December 6, 2013
 Addendum No. 2
 to
REQUEST FOR PROPOSALS
BAIFA Express Lane Network
Toll System Integration & Maintenance
 dated November 7, 2013

This letter is Addendum No. 2 to the Request for Proposals BAIFA Express Lane Network Toll System Integration & Maintenance, dated November 7, 2013 (RFP). Where text is revised, deleted text is shown in strike-through format; added text is *italicized*. The RFP is revised as follows:

Figure 1 - I-680 Conceptual Alternative
Acosta Blvd. to Livorna Rd.

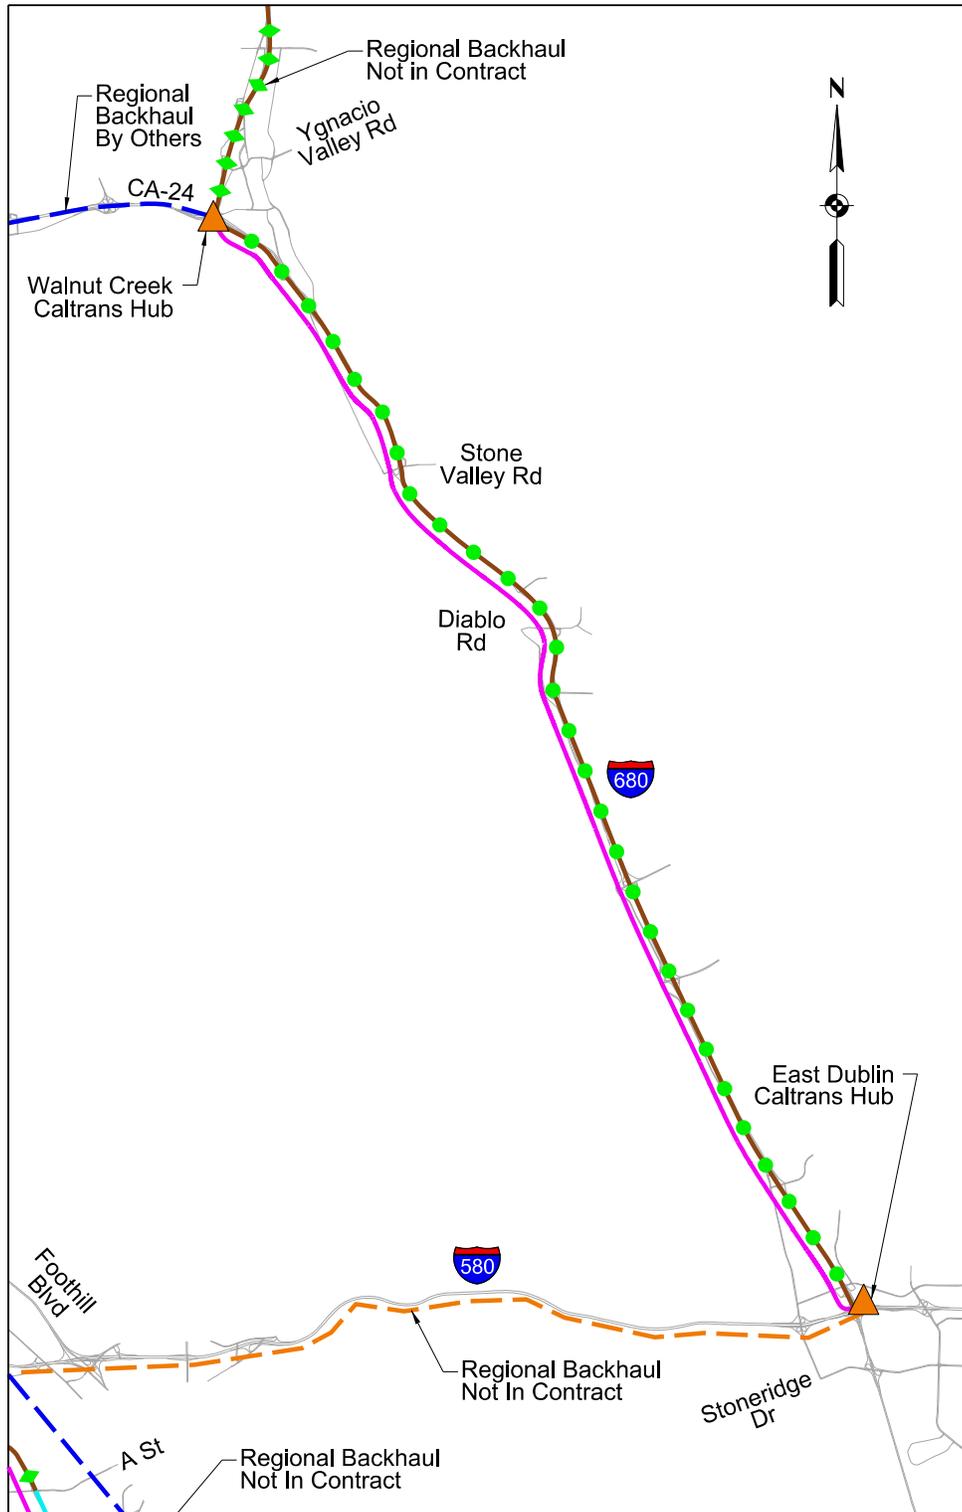
<u>Addendum Item</u>	<u>Reference</u>	<u>Change</u>
	Network Conceptual Predesign, Page 18	<i>demarc locations.</i>
45.	RFP Appendix 1, Attachment A, Reference 4: Communications Network Conceptual Pre-Design, Page 34-39, Figures 1-5	See Addendum 2, Appendix 4, attached hereto, for updates to the Communications Network Conceptual Pre-Design, Page 34-39, Figures 1-5.

TITLE	
Communication Responsibility Demarcation	
SCALE	PAGE
None

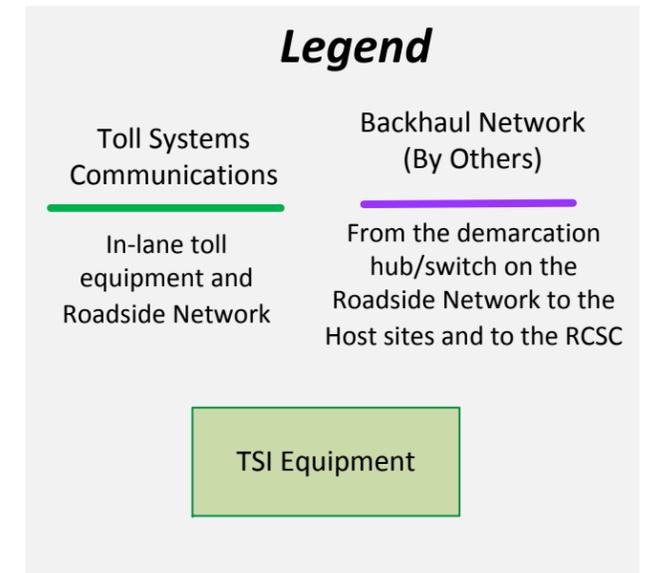
Toll equipment communications and Corridor Roadside Network will be designed, installed and maintained by TSI. Civil work for trenching and conduit installation will be done by a civil contractor.

⚠ Roadside Network Communications by TSI. Connection shall be by various methods as determined in the Critical Design.

TITLE	
Toll System Sample Layout	
SCALE	PAGE
None

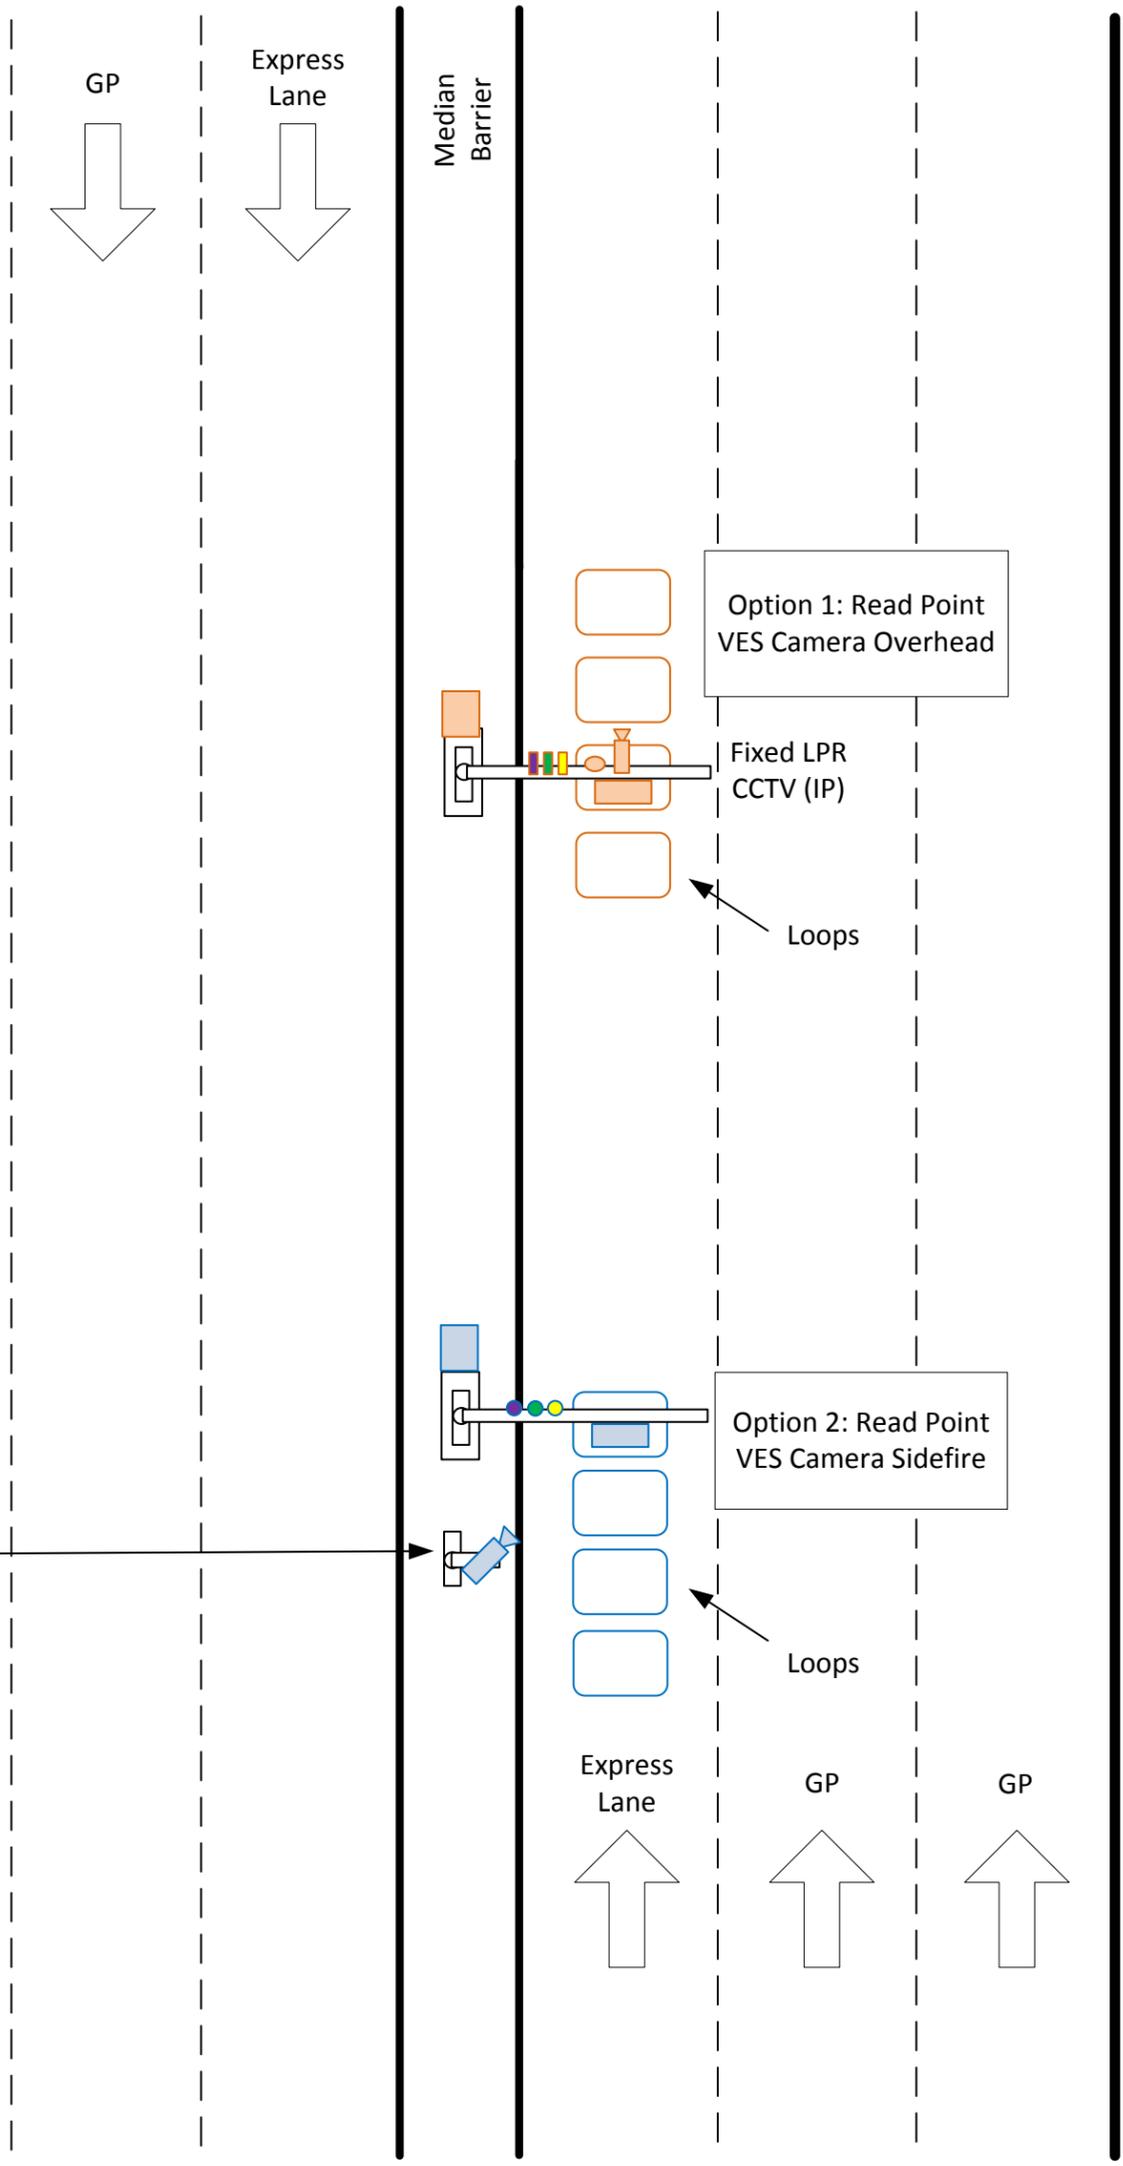
47.	RFP Appendix 1, Reference 2, <u>Typicals</u>	See Addendum 2, Appendix 7, attached hereto, for revised typicals clarifying VES equipment mounting constraints for the side-fire option and the sign structure overhang distance over the express lane.

Note: VES equipment in the side fire option shall not overhang the roadway
